CONSTRUCTION DOCUMENTS REVIEW

14 May 2008

RE: QUIZNOS SUB
Clinton C&G Store # 6447
101 Johnston Pl.
Clinton MS 39056

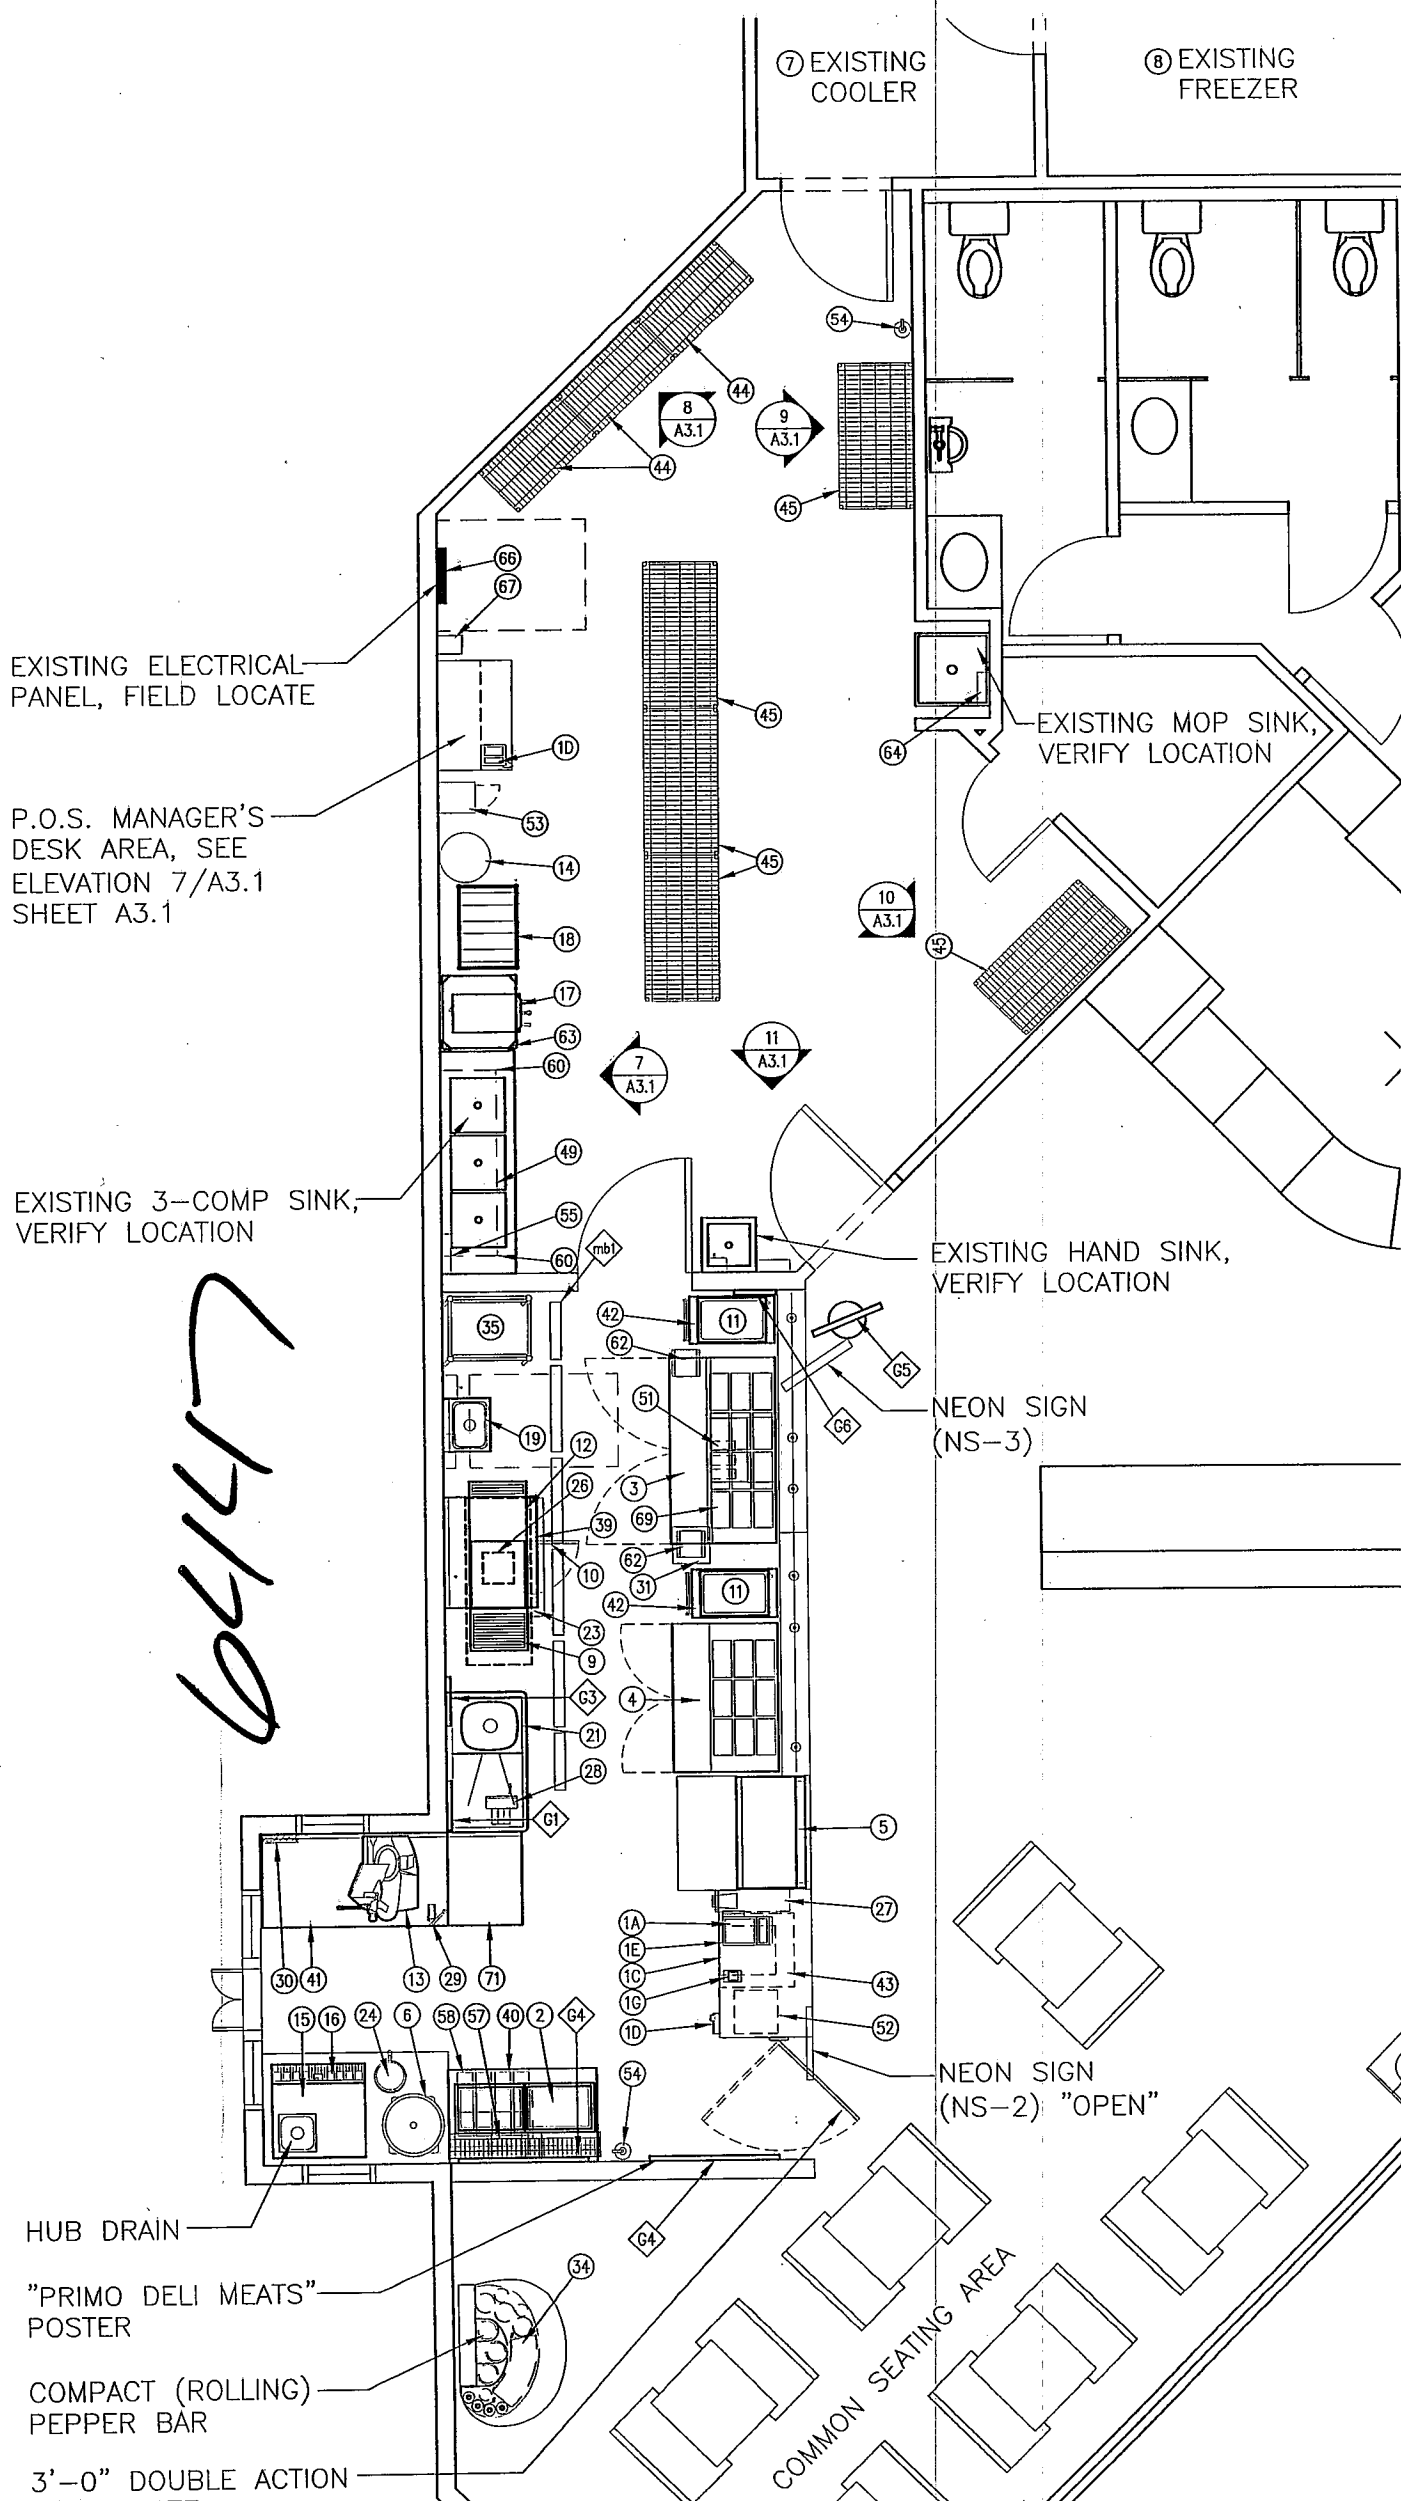
- c. **Refer to prototype for correct wall covering placement.** V2 to be placed behind the beverage counter; remove V2 from the front Millwork area (see attached for both)

- d. A ~~standard~~ Q-Vent will be ordered per the QVent worksheet.
 - e. An existing cooler & freezer is noted & will not be ordered per the Kolpak worksheet, **verify.**

- f. A ~~208v~~ toaster will be ordered, **verify.**
 - g. **Effective immediately- Place the toaster oven 6" to 8" away from the FRP to prevent the FRP from melting due to high temperatures from the toaster oven.**

- h. **Verify clearance of service line due to toaster moving.**
 - i. **Verify two (2) 20-amp circuits are provided for the soup station.**
 - j. All millwork will be ordered as standard prototype sizes.

- k. Note: all sneeze guard glass must be angled 15 degrees, **verify.**
 - l. The electrical panel has been noted as ~~existing~~ and will not be ordered.

- m. Add FRP W1 to the font Millwork walls (see attached)
 - n. Existing flooring & ceiling noted & has not been ordered. **Verify**
